SPECIAL AIRWORTHINESS INFORMATION BULLETIN

CE-03-16
January 6, 2003

This Special Airworthiness Information Bulletin (SAIB) provides safety information to **Schempp-Hirth Model Nimbus-3/24.5**, all serial numbers, sailplane owners on the following:

No. 286-34

ELEVATOR ACTUATING BRACKET

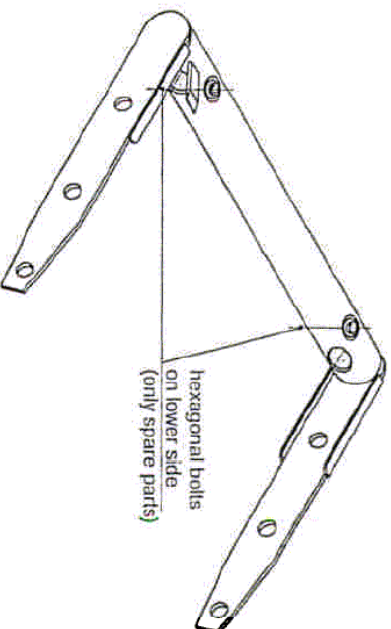
Play in the tailplane attachment bracket

If an excessive vertical play is found at the tips of the horizontal stabilizer, then the adjustable bushings of the elevator actuating bracket should be tightened such (using a 4 mm Allen Key) that the tailplane will just slide onto its locating pins.
